DESIGN REVIEW: RECOMMENDATION

1422 SENECA STREET, SEATTLE, WA 98101

PROJECT #:3034493-EG

EDG - 8/14/19 (12 STORY)

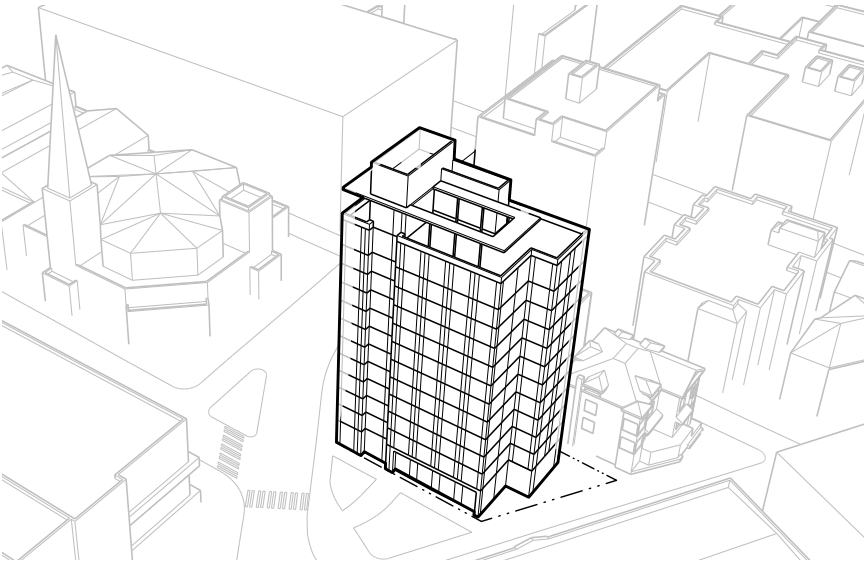
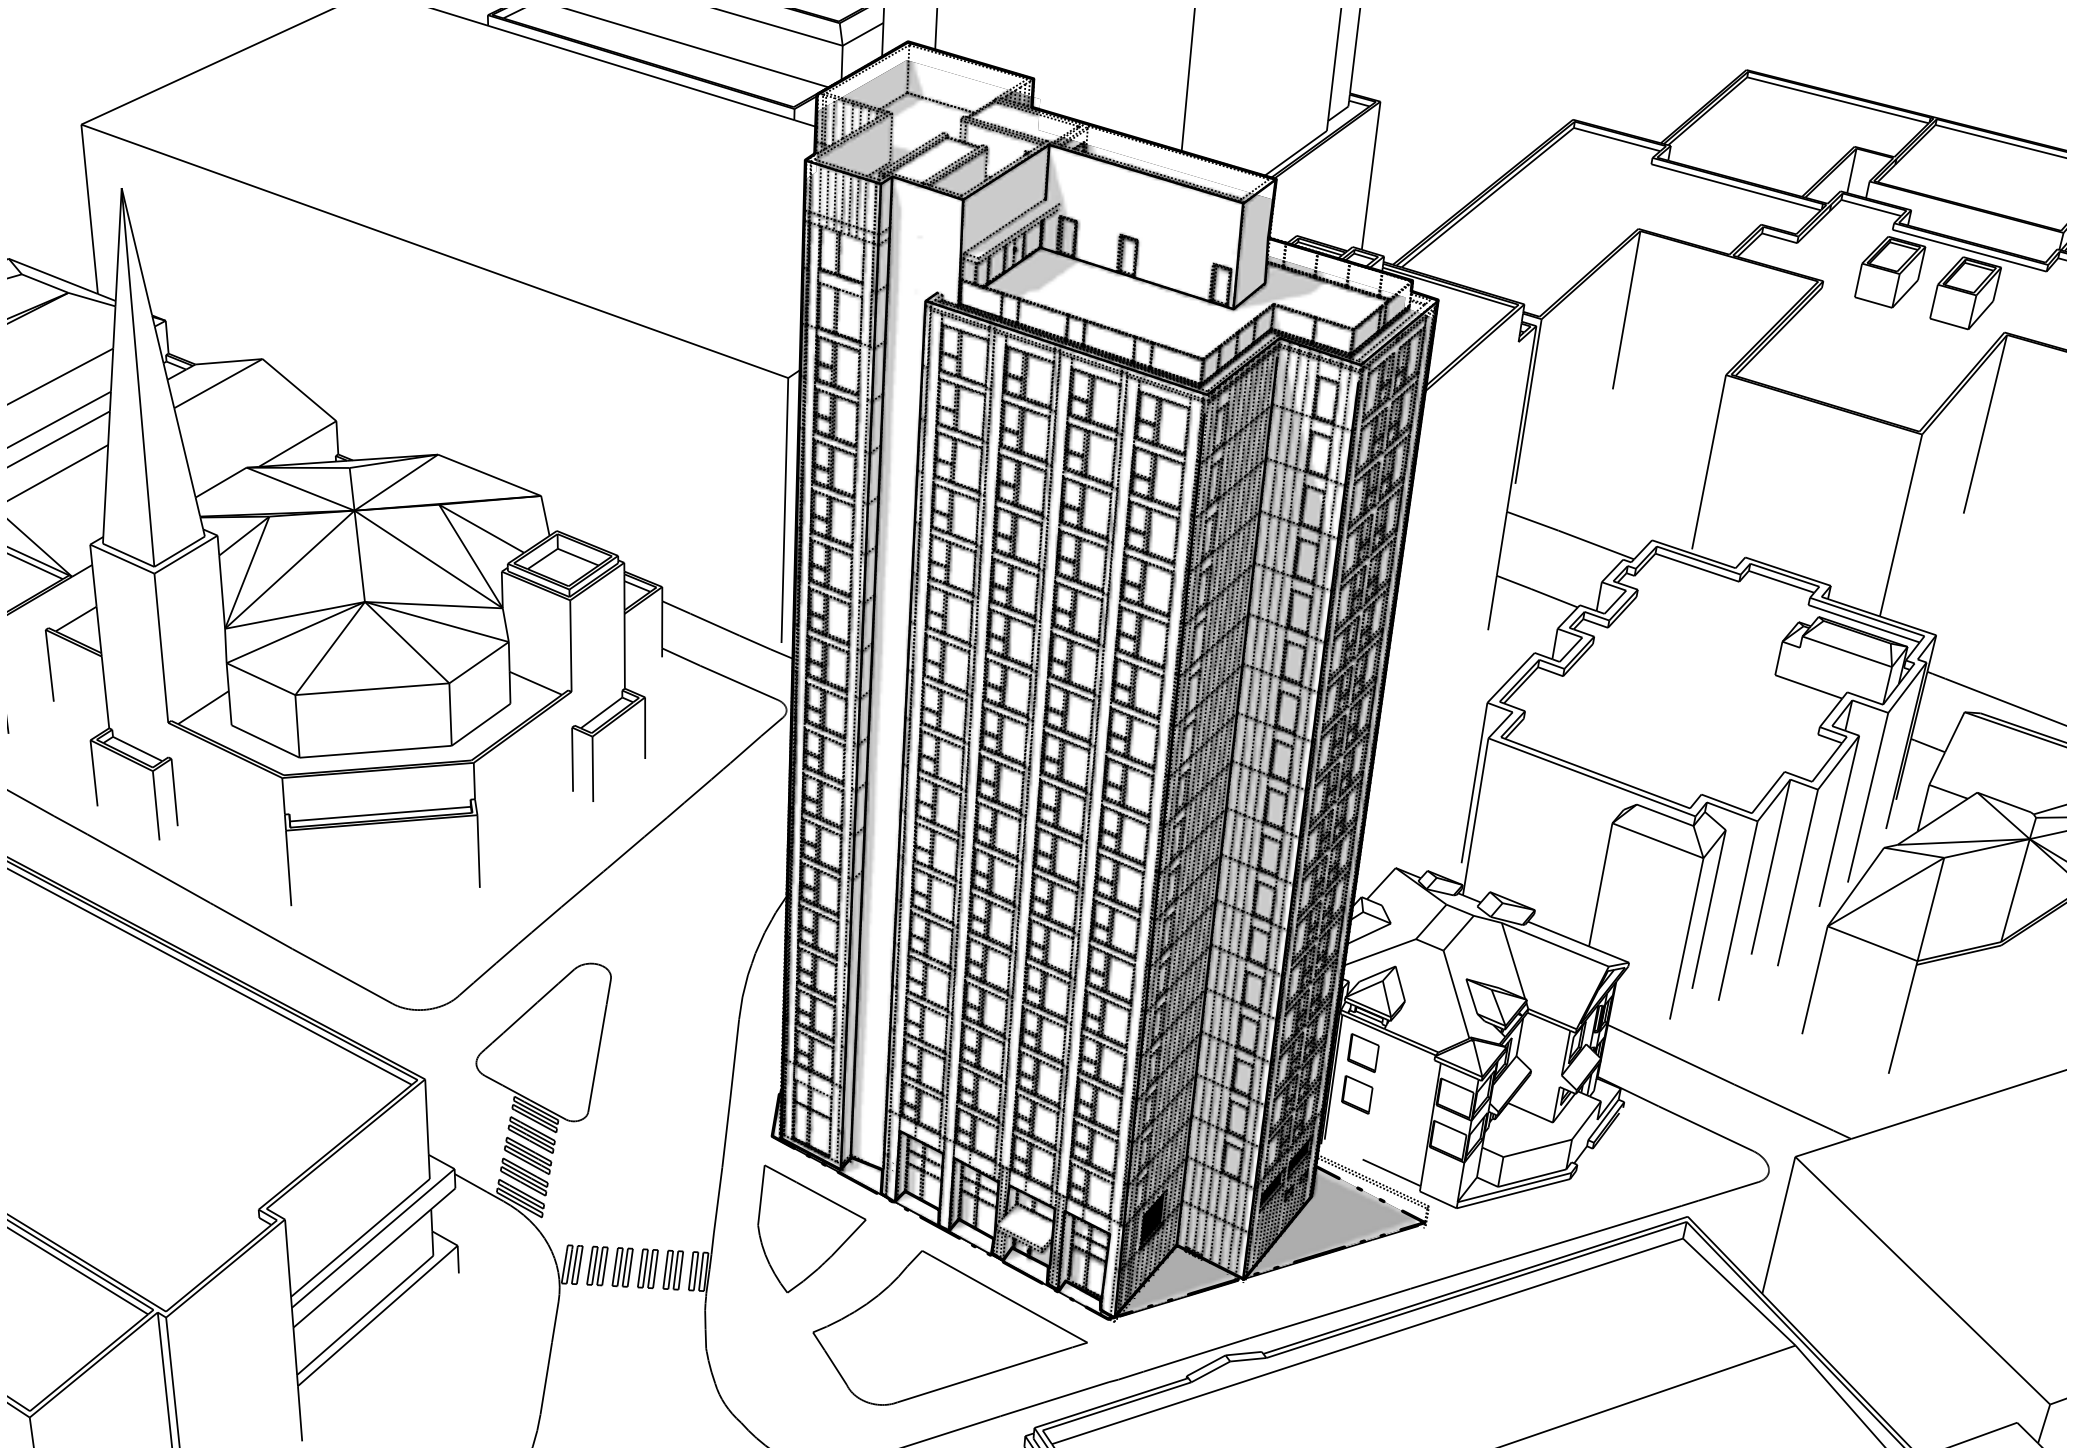
The Board supported the thinness of the massing for both it's expression of the innovative construction type and it's potential to lessen impacts on light and air on adjacent sites and streets.

The Board expressed concerns regarding the roof canopy expression in the preferred option, and requested further study of this element and it's role in the larger composition.

Building massing is consistent with the early design guidance preferred scheme. The triangular shaped lot allows the building to step back from adjacent streets, while the proposed courtyard minimizes light and air impacts on adjacent buildings.

The secondary roof canopy has been removed and the south massing has been extended to integrate a smaller canopy at the elevator penthouse.

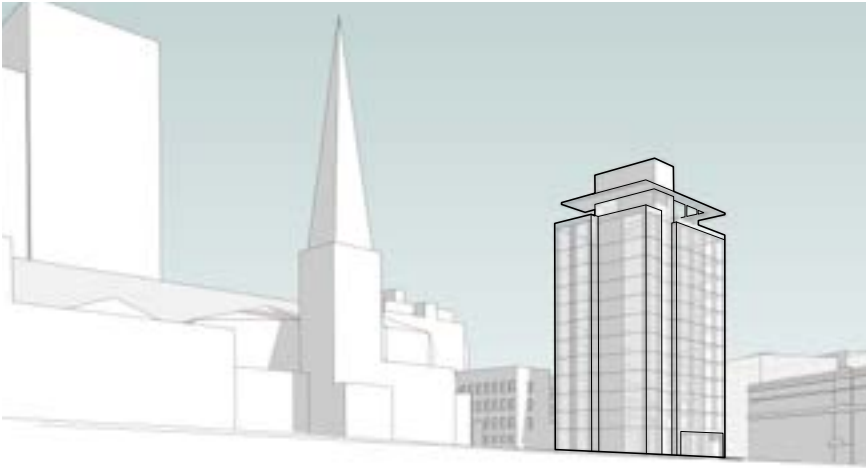
The Board questioned the connection between the height of this project and that of the spire at the landmarked Seattle First Baptist Church, and asked that a more rigorous conceptual analysis be developed of the forms in this neighborhood and this proposals response to that context.

The height of the building is not tied to the church spire, rather the height is an intermediate tower that is appropriate at the edge of the highrise zone. The building takes advantage of views to Seattle First Baptist Church.

1 - SECTION AT AMENITY AREA - PUBLIC PLAZA

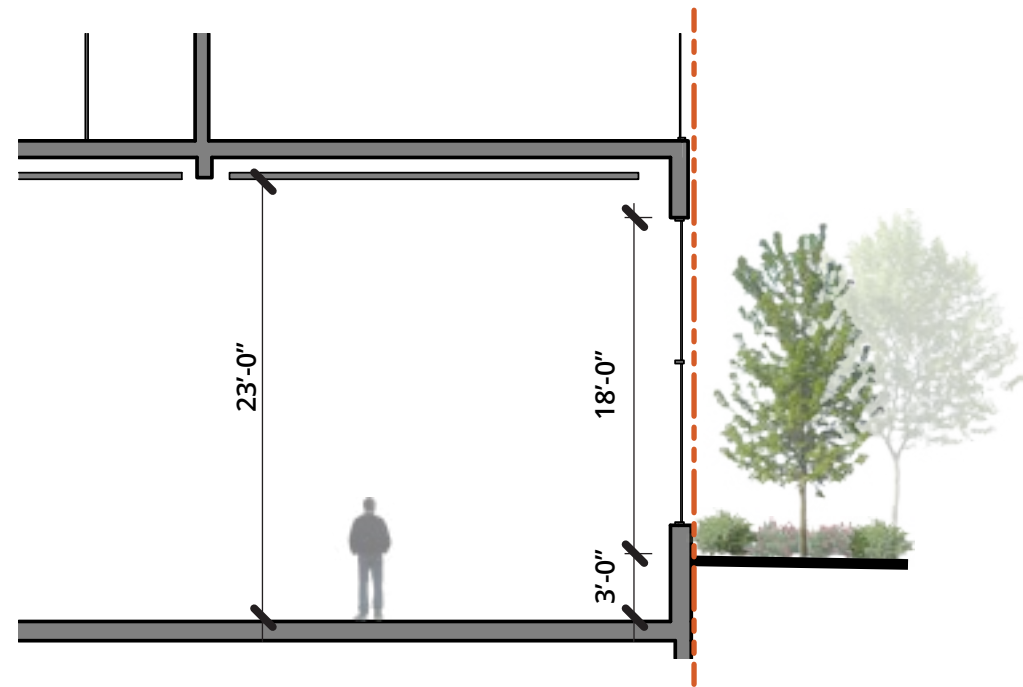
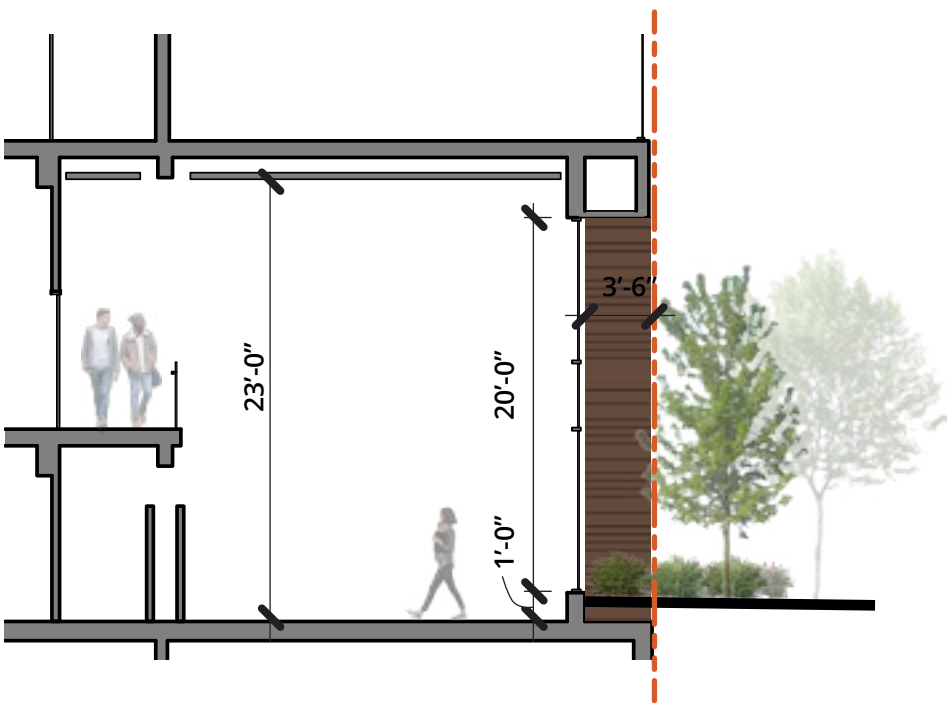
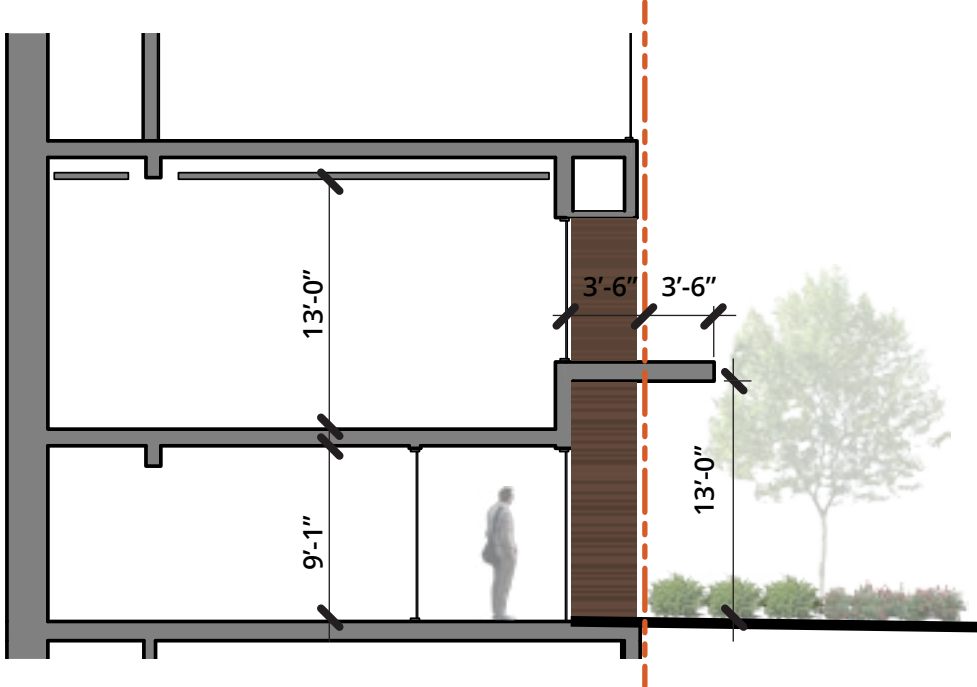
The Board was concerned to find few details regarding the design of the ground plane and pedestrian experience. The Board provided guidance with those edges should activate the sidewalk without appropriating the associated public spaces, and that complete details be provided for the next meeting, including entrance locations, inside/ outside relationships, resolution of grade issues, and the courtyard area fronting Maxmillian apartments.

The Board recognized that the park-like triangle of space directly north east of the site is part of the city right of way, but emphasized how important the development of this space would be to the pedestrian experience of this project.

The public right of way will be developed as part of this proposal to create a neighborhood amenity with public seating, lighting and gathering space. Sections provided at the ground floor transitions represent the resolution in grade through landscaped areas.

The public plaza will include public seating, lighting and gathering space. The primary residential entry is accessible from the new plaza. The public plaza will add to the evolving First Hill network of public spaces. See landscape for more details.

1 - SECTION AT REAR COURTYARD

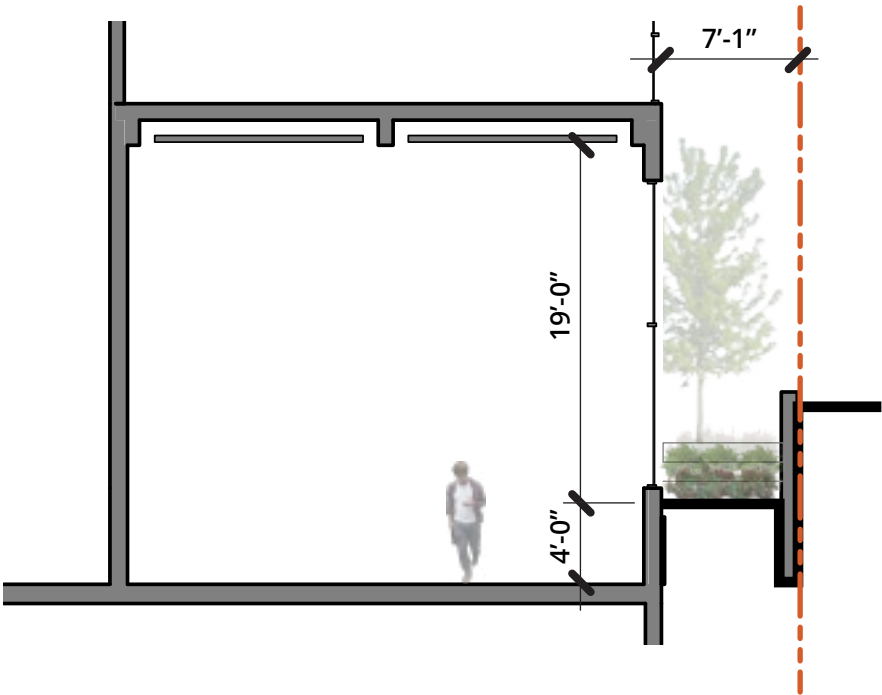
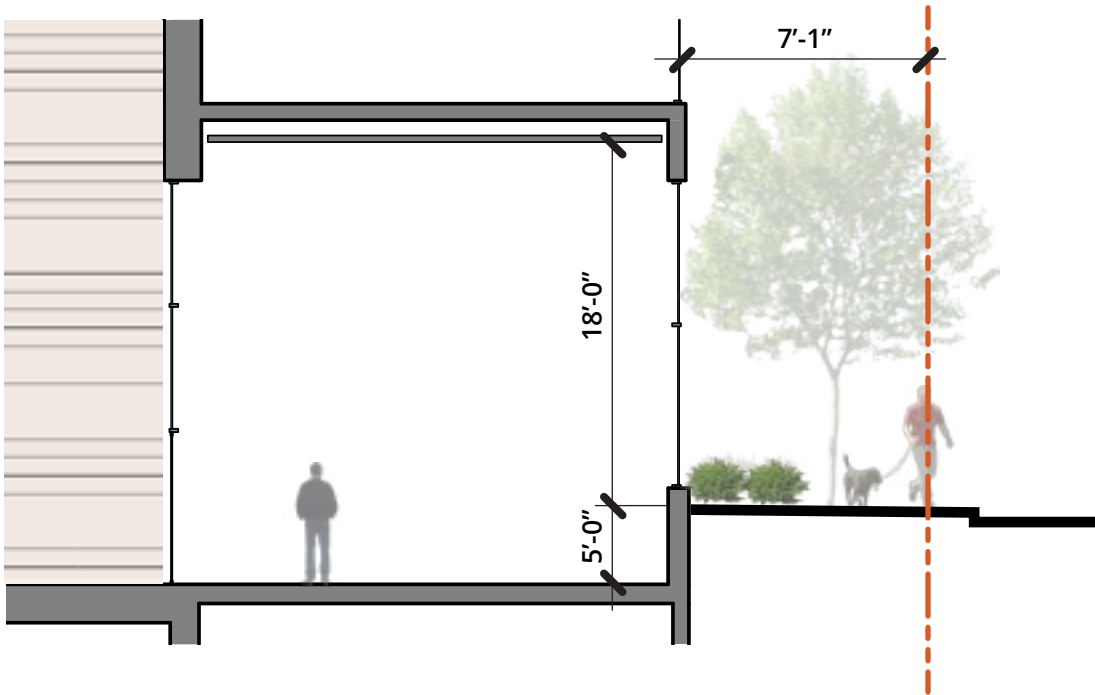
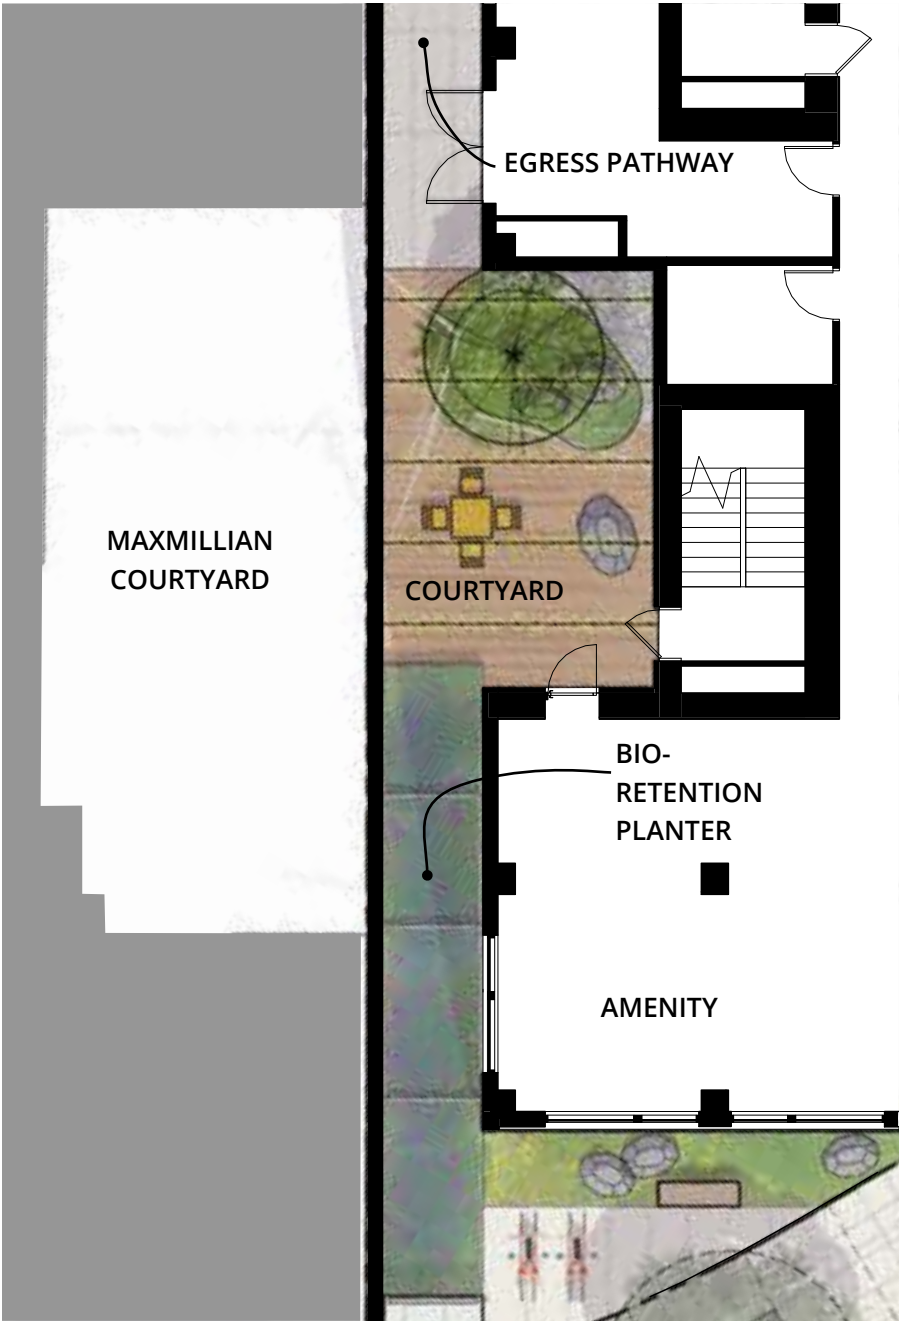
The Board recognized that the concrete base that typically creates a podium expression would not be required for this project, but agreed that a change in exterior expression recognizing connection to the ground would likely still be appropriate.

The 'base' is defined by a tall ground floor with large expanses of glazing that is recessed in the CLT structural grid. The horizontal datum is thickened at the transition between the ground floor uses and the upper floor residential language above.
